# CITY OF ALBUQUERQUE

**Re: BEK Distribution Facility (PHASE 1)**  
**601 Gallatin PI NW, 87121**  
**30-Day Temporary Certificate of Occupancy**  
**Transportation Development Final Inspection**  
Engineer's/Architect's Stamp dated 7-29-19 (J10D002G1)  
Certification dated 5-13-21

**RE: SITE PLAN FOR BUILDING PERMIT CERTIFICATION  
REQUEST FOR PERMANENT CERTIFICATE OF OCCUPANCY  
BEN E. KEITH DISTRIBUTION CENTER, 601 GALLATIN PLACE, NW, 87121**

C101

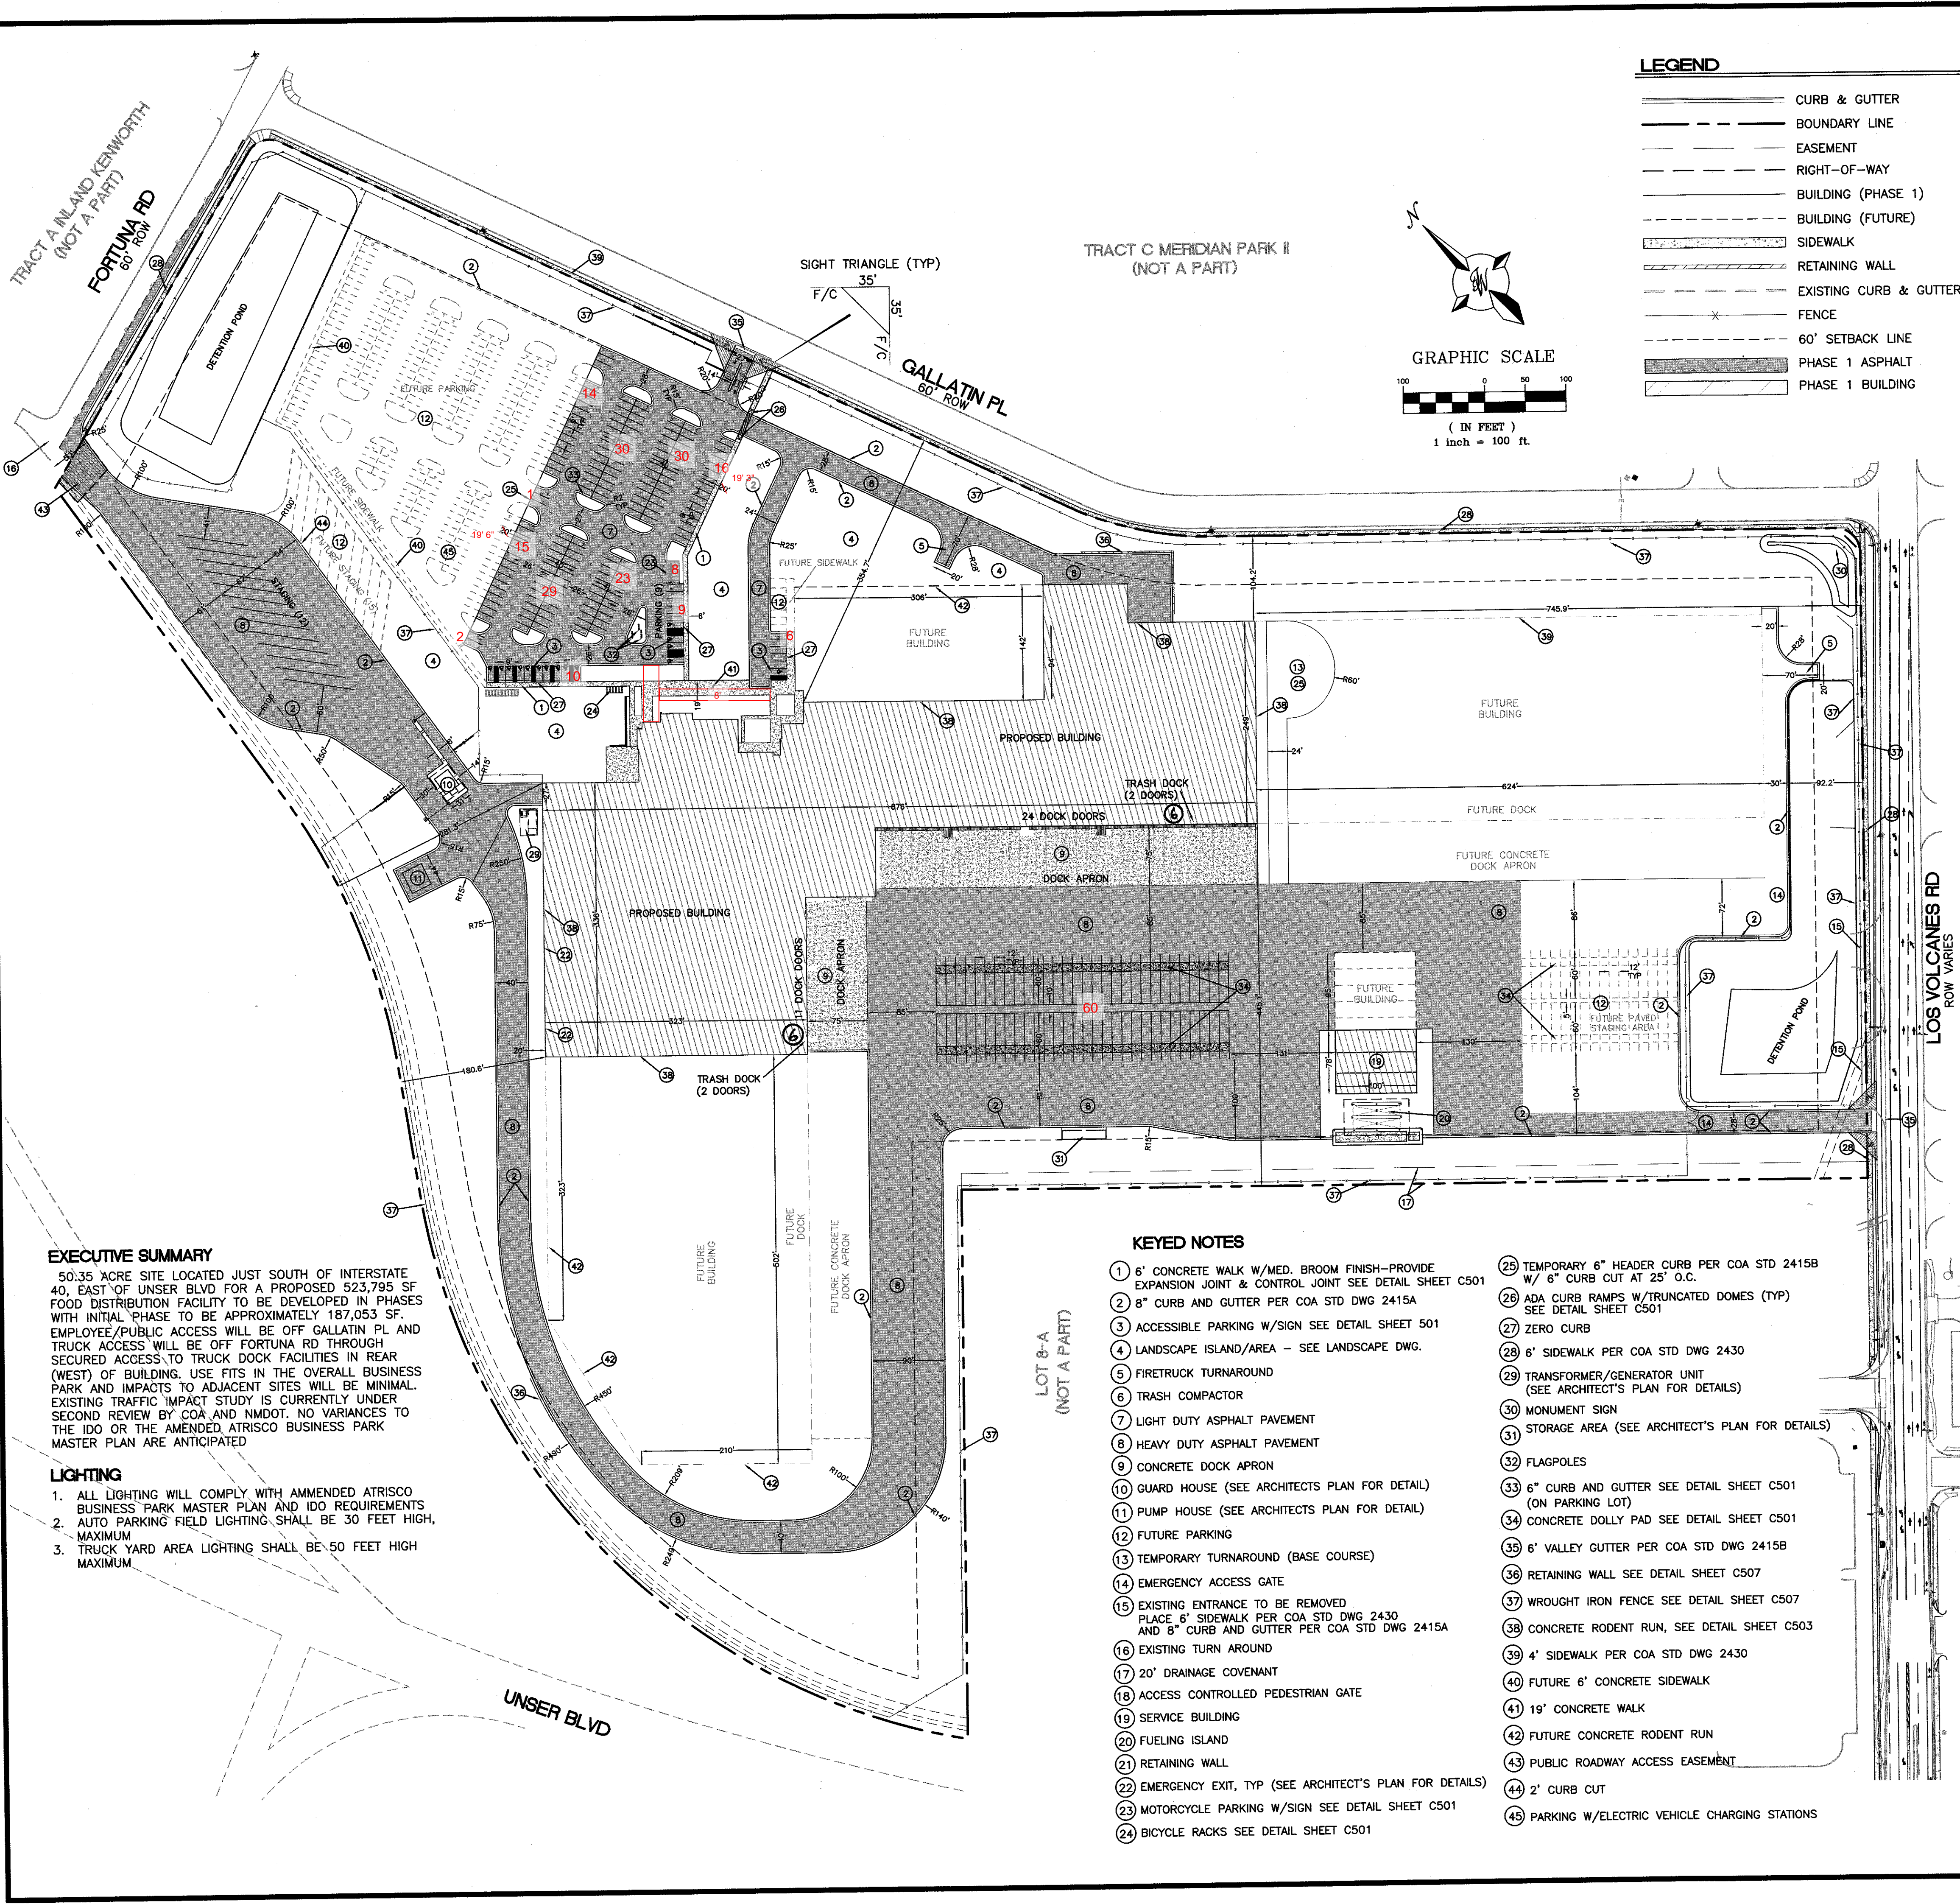
1. The ADA access aisles shall have the words "**NO PARKING**" in capital letters, each of which shall be at least one foot high and at least two inches wide, placed at the rear of the parking space so as to be close to where an adjacent vehicle's rear tire would be placed. (66-1-4.1.B NMSA 1978)
2. Van accessible aisles should be 8ft wide; all others should be 5ft wide.

Once these corrections are complete, email pictures showing the changes to [PLNDRS@cabq.gov](mailto:PLNDRS@cabq.gov), and submit an administrative fee of \$40.
